**CITY OF SACRAMENTO**

**Permit No: 9809755**

**Site Address: 3400 20TH AV SAC**

**Nature of Work: REROOF AND SERVICE CHANGE**

FLOOR PLAN SCALE: 1/4" = 1'-0"

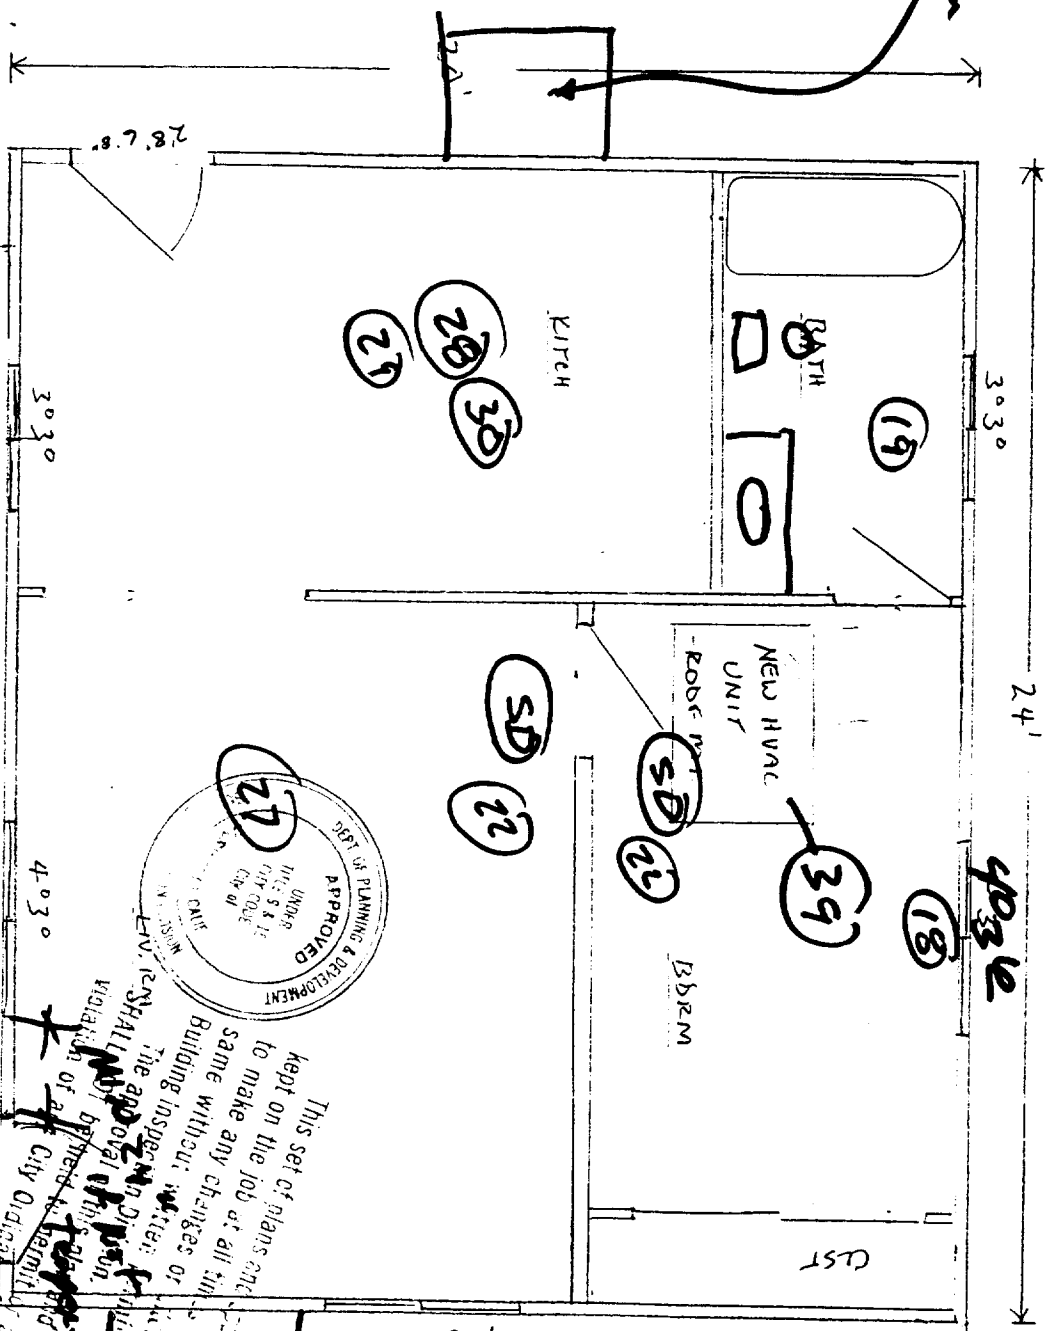
NOTE: HVAC UNITS REQUIRE  
ADDITIONAL DESIGN  
REVIEW

(36) (37) (39)

(41) (20) (33)

REAR ELE. SCALE : 1/4" = 1'0"

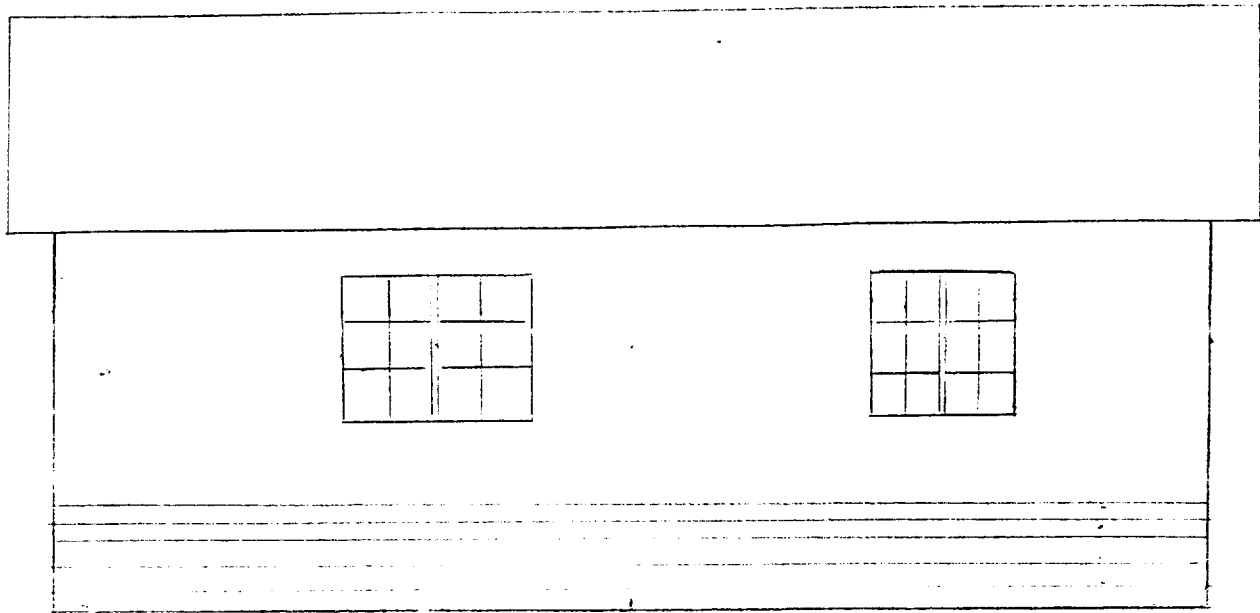
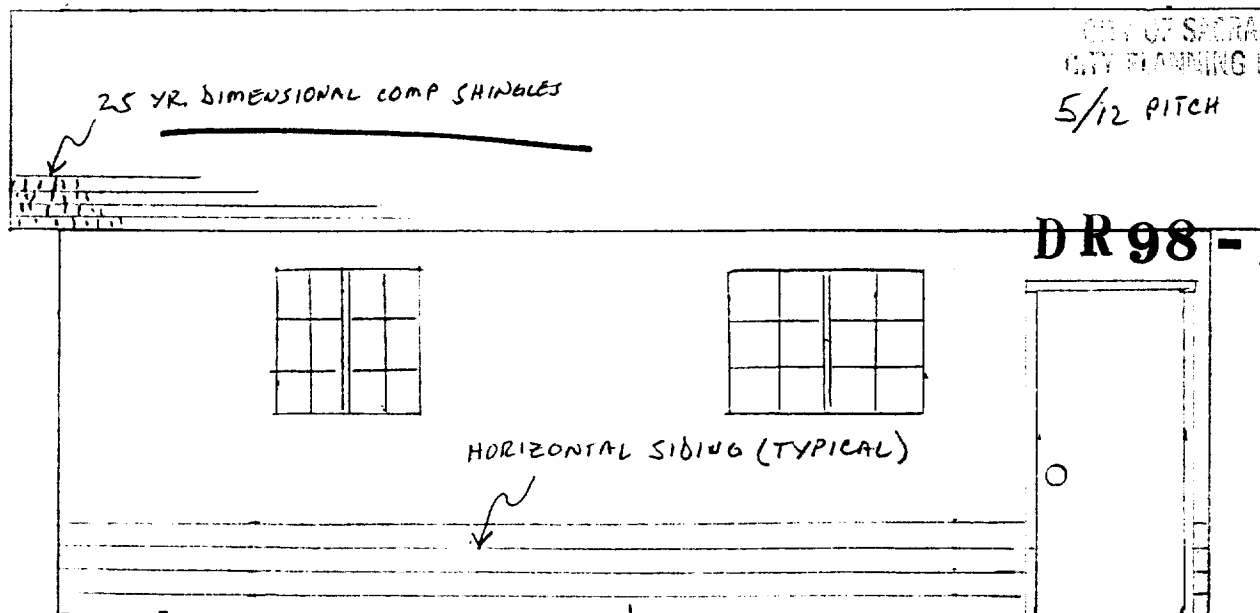
WINDOWS  
DOORS REQUIRE  
SILL TRIM

FRONT ELE. SCALE : 1/4" = 1'0"

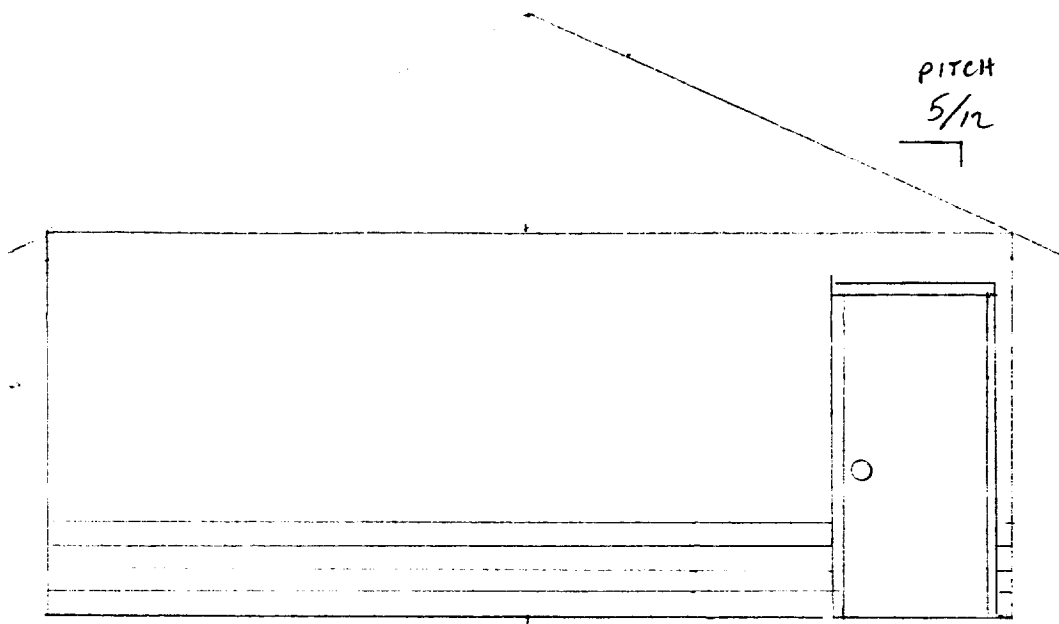
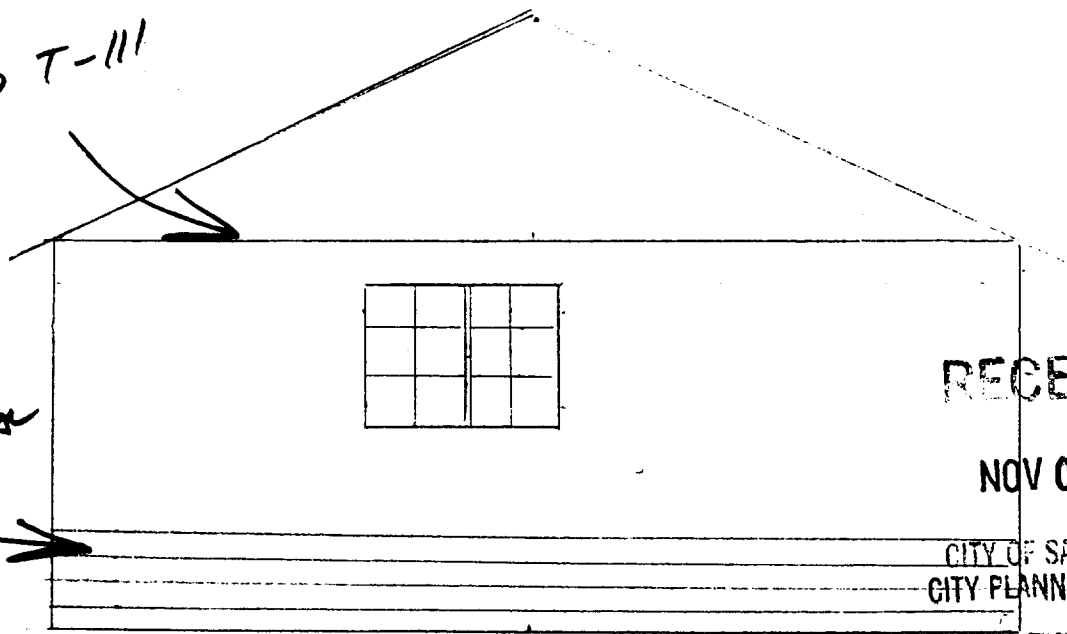
WINDOWS & DOORS  
REQUIRE SILLS, TRIM

NO T-III

Horizontal Siding

REAR ELE. SCALE: 3/16" = 1'-0"

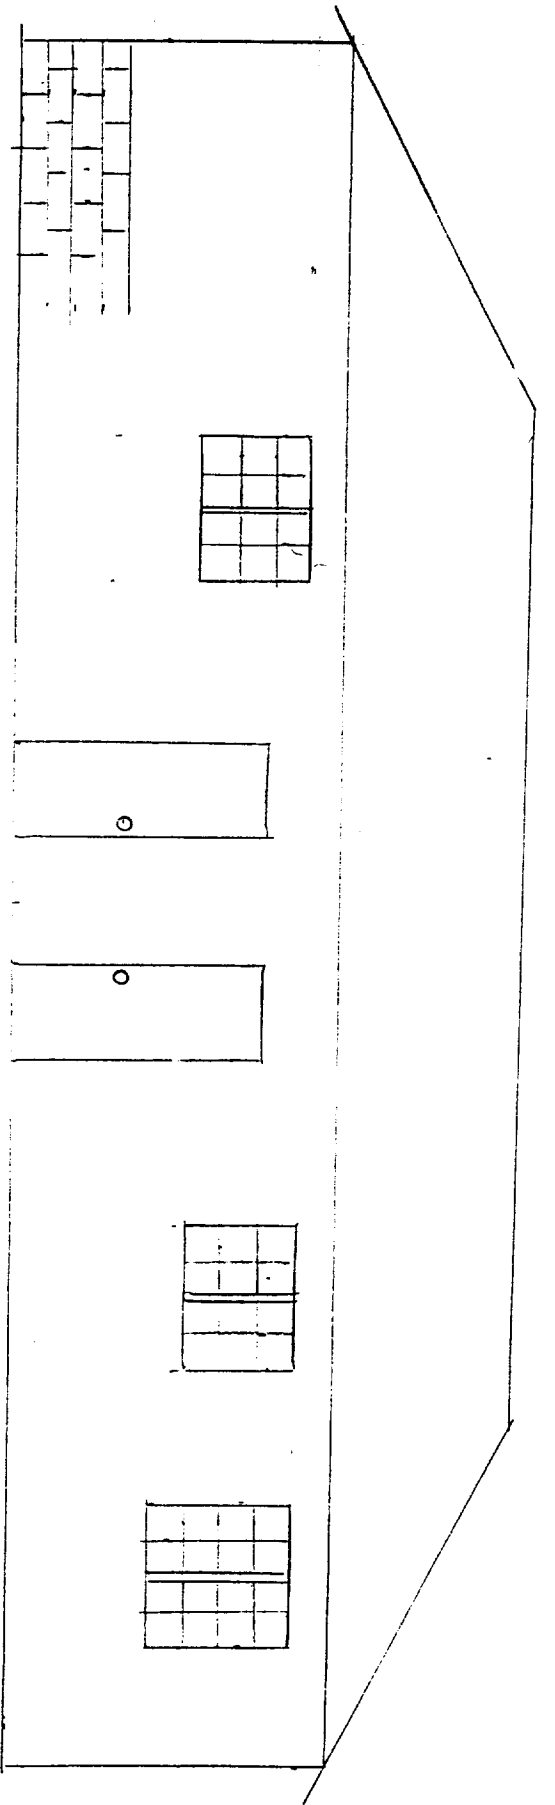
WINDOWS & DOORS 'SIZES'  
REQUIRES FINISHES

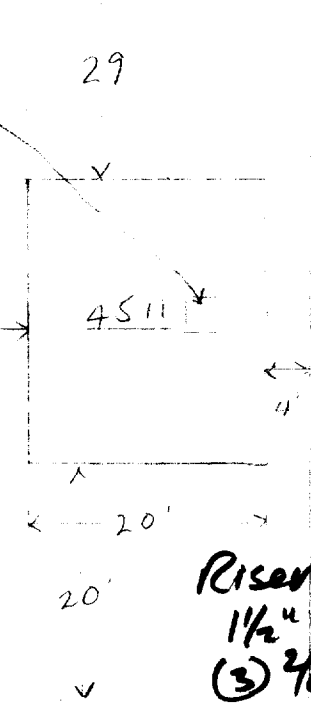
Mains REQ'd. at  
each panel —  
Provide ground at  
2nd Bldg.

If established water grid —  
use additional grid Rod —  
If not use Ufer ground &  
bond to interior water &  
gas piping

Riser min  
1 1/2"  
(3) 2/0 cu 75°C
